AS CONSTRUCTED PLANS

PROJECT NO. : 8 11 50 701
F.A. NO. : FBDNHS-306(001)
T.I.P. NO. : F-2800
COUNTY : BEAUFORT
DESCRIPTION : Pamlico River Ferry Basin Ramps ON
NC-306 Between Aurora and Both.
DIVISION NO. : TWO
CONTRACTOR : HMG, INC.
812 N. ELM ST.
GREENSBORO, NC 27401
DIVISION ENGINEER : MR. G.R. SHIRLEY, JR., P.E.
RESIDENT ENGINEER : MR. J.A. WOLF, JR., P.E.

LOCATION : N.C. 306 AT PAMLICO RIVER FERRY
 TYPE OF WORK : GRADING, PAVING, BULKHEAD REPLACEMENT,
 RECONSTRUCTION OF FERRY RAMPS, AND STRUCTURES

STATE OF NORTH CAROLINA					
DEPARTMENT OF TRANSPORTATION					
RALEIGH					
PAMLICO RIVER FERRY					
NORTH RAMP AND SOUTH RAMP					
SEPT			1992		
REVISIONS					
NO.	BY	DATE	NO.	BY	DATE
1	FAM	1-7-94	3		
2			4		
TOTAL SHEETS					20

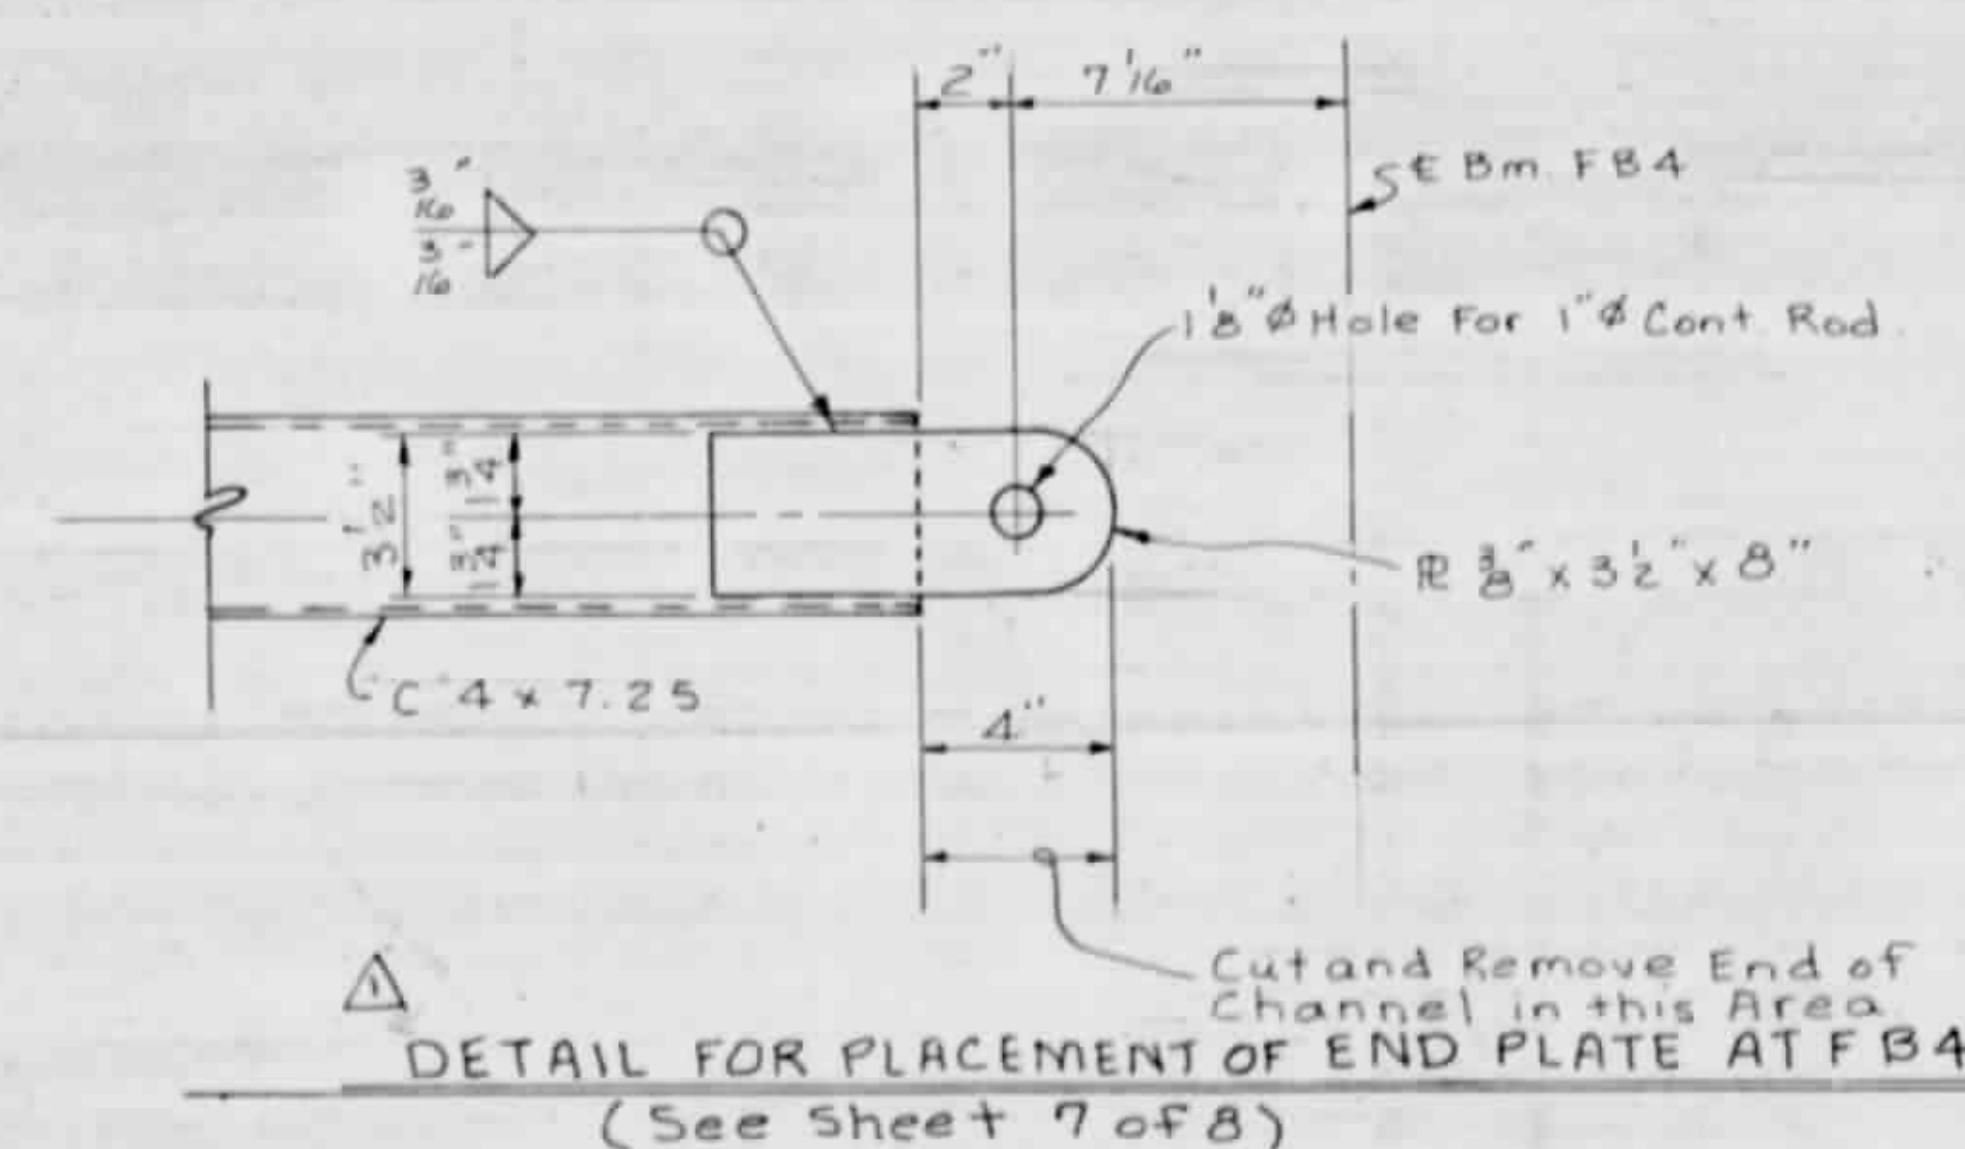
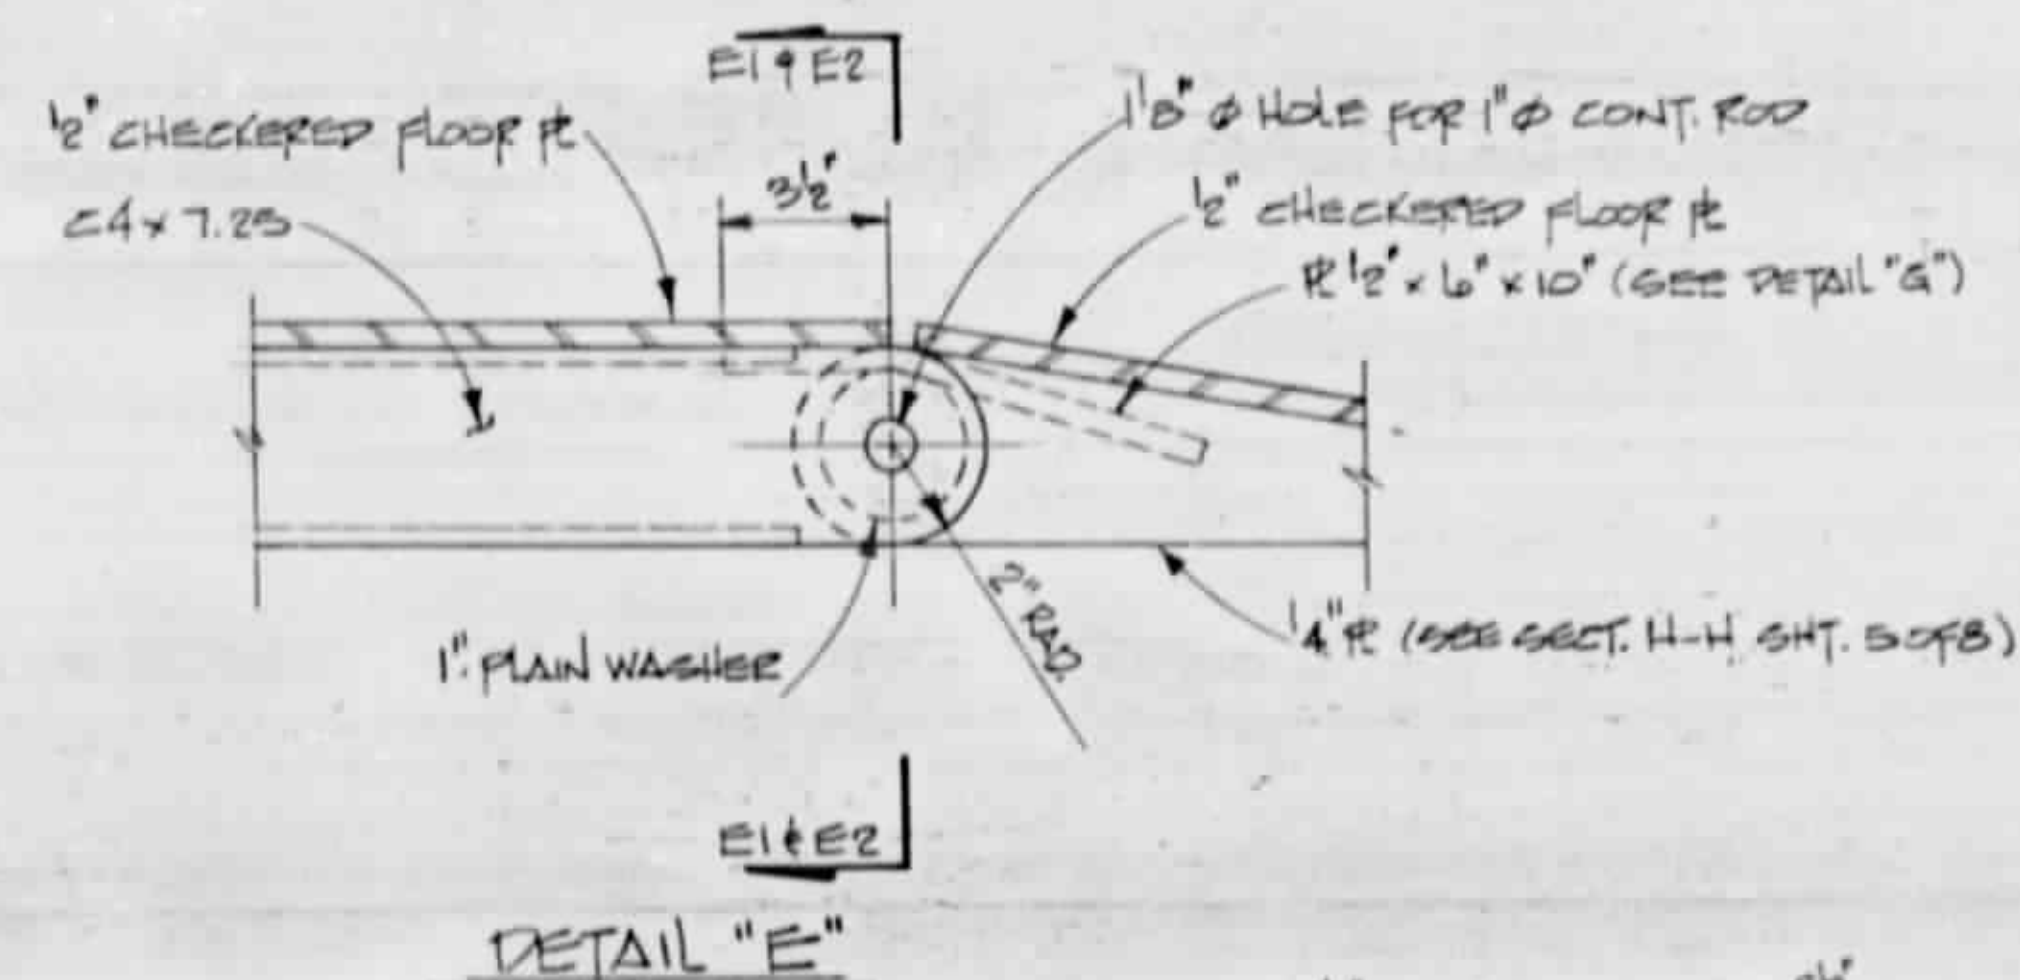
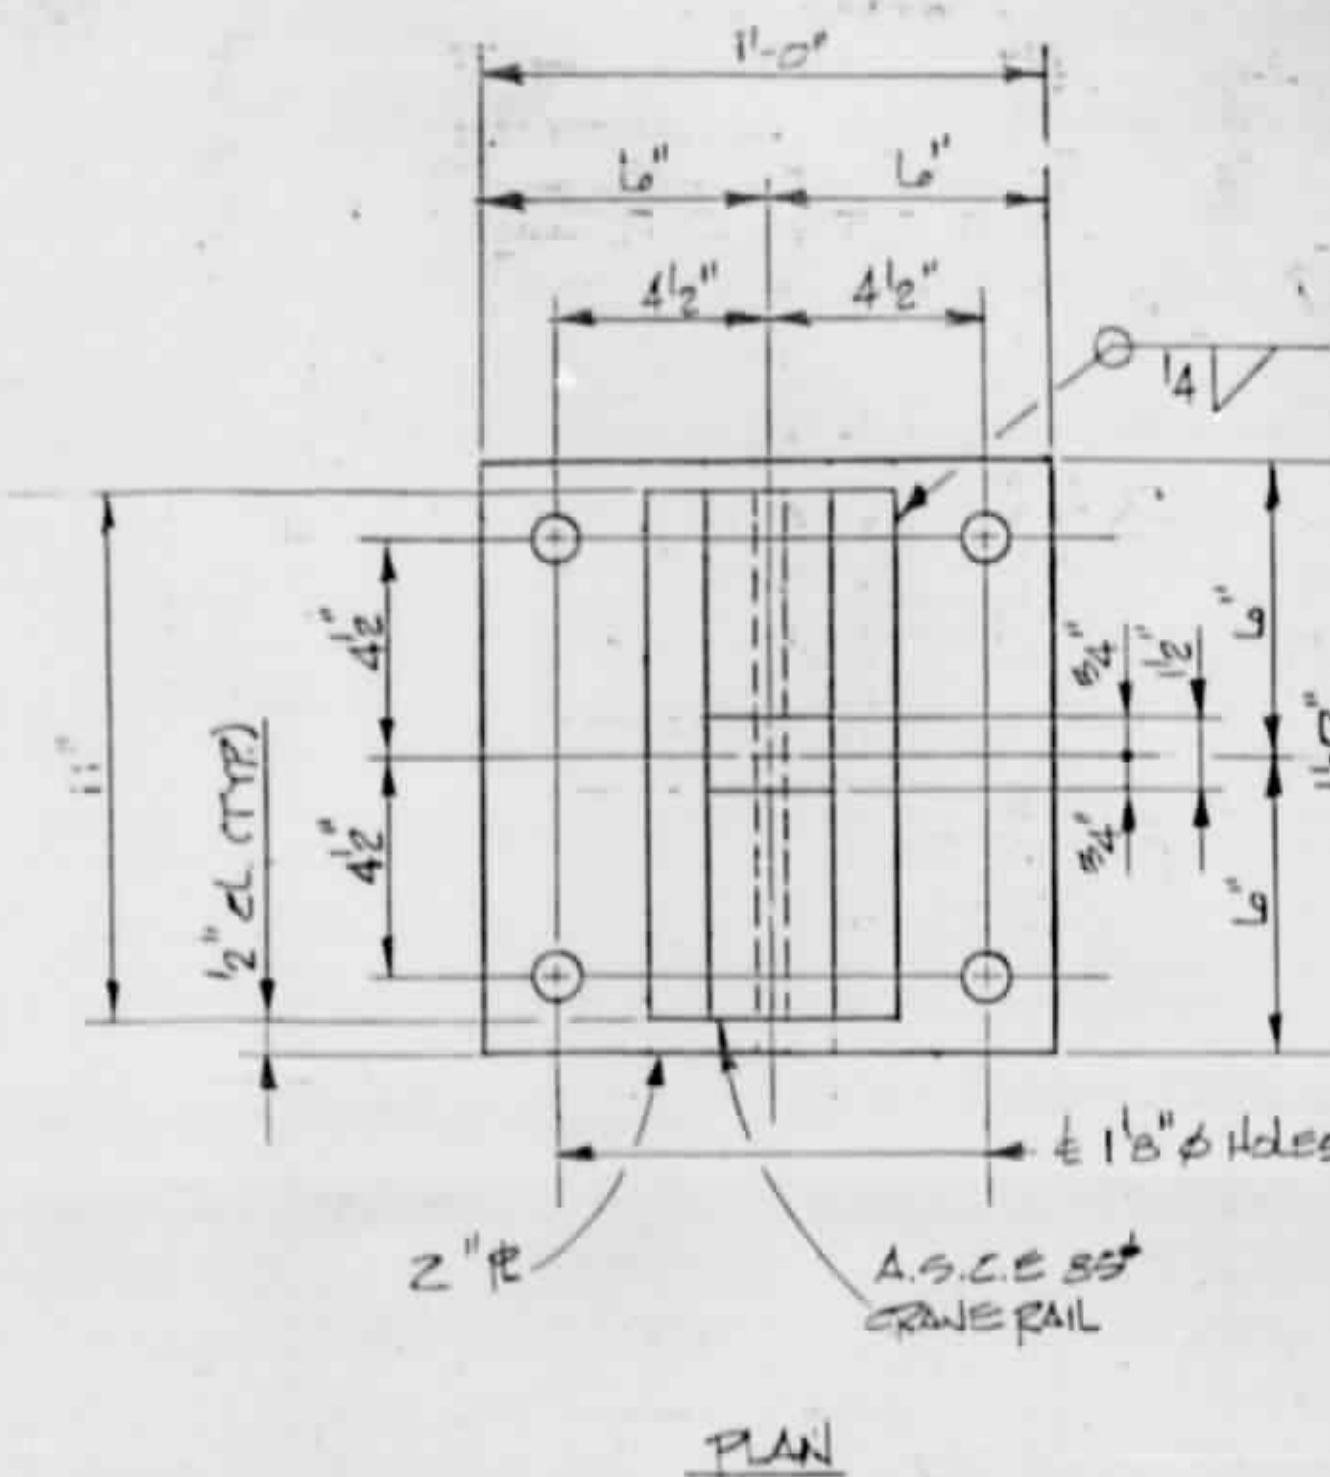
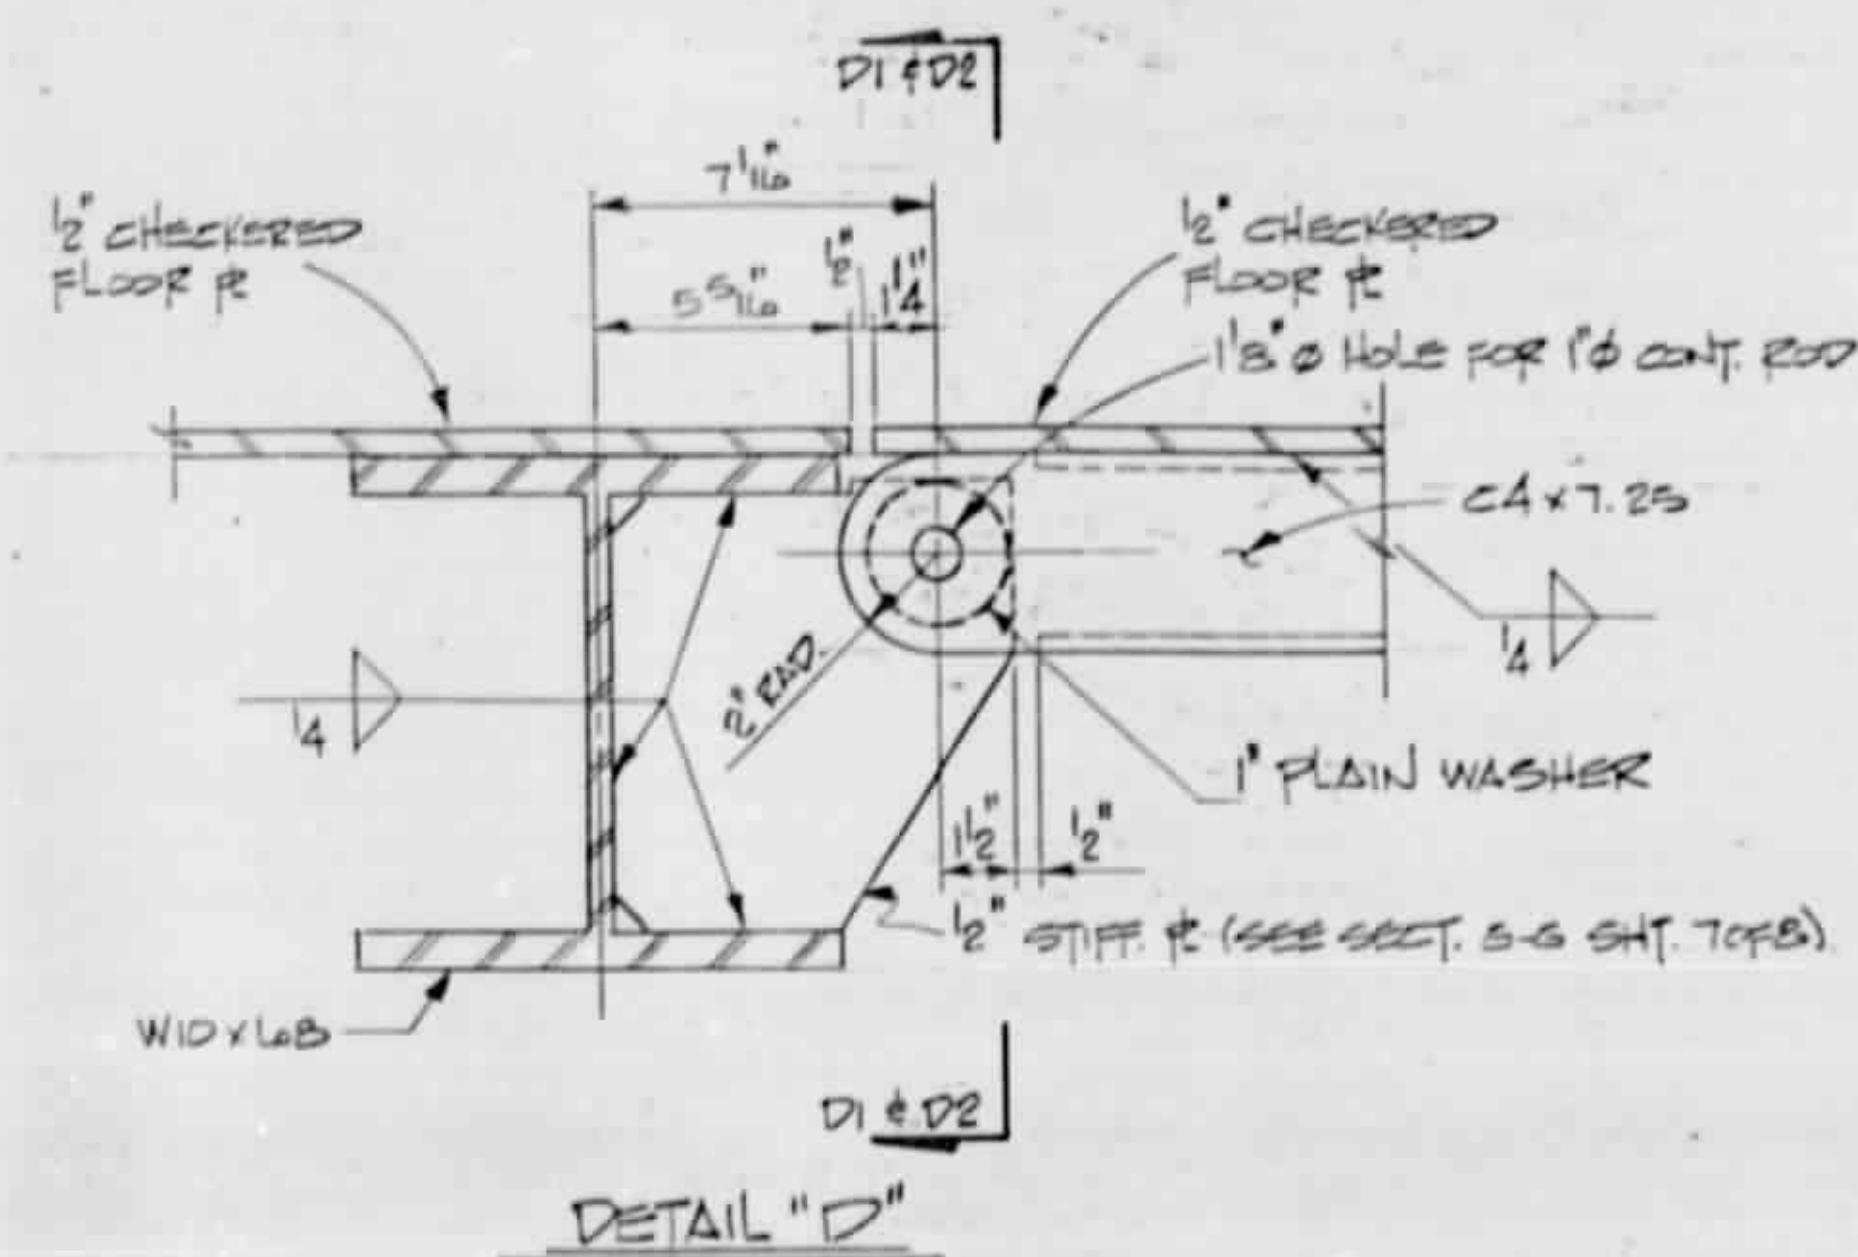
△ Rev No.1 Added Half 3" Pipe in Section C-C By FAM v By PER

STATE OF NORTH CAROLINA
DEPARTMENT OF TRANSPORTATION
RALEIGH
PAMLICO RIVER FERRY
NORTH RAMP AND SOUTH
RAMP

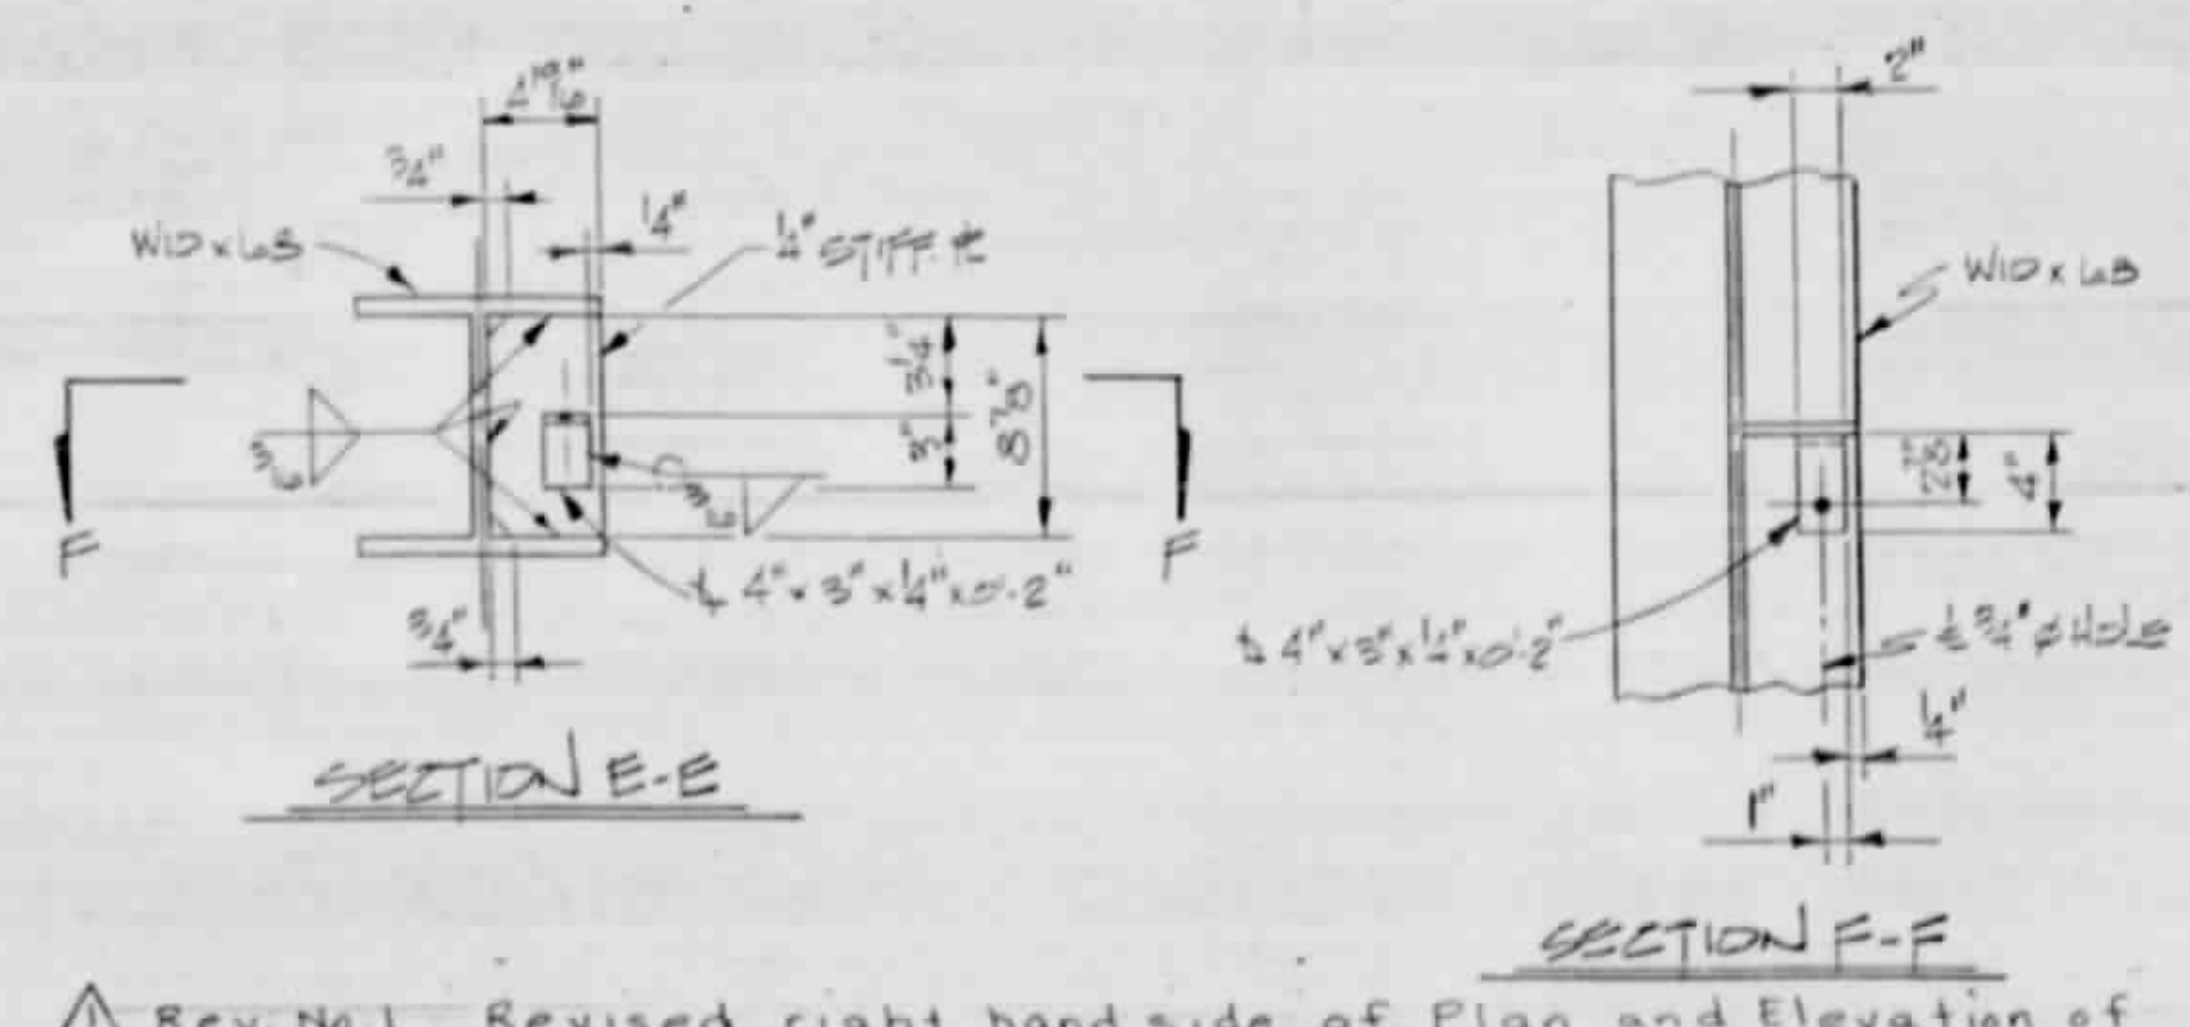
1 Rev No:1 Added Half 3" Pipe to Elevation and Detail "F".
By: FAM ✓ By: PEK
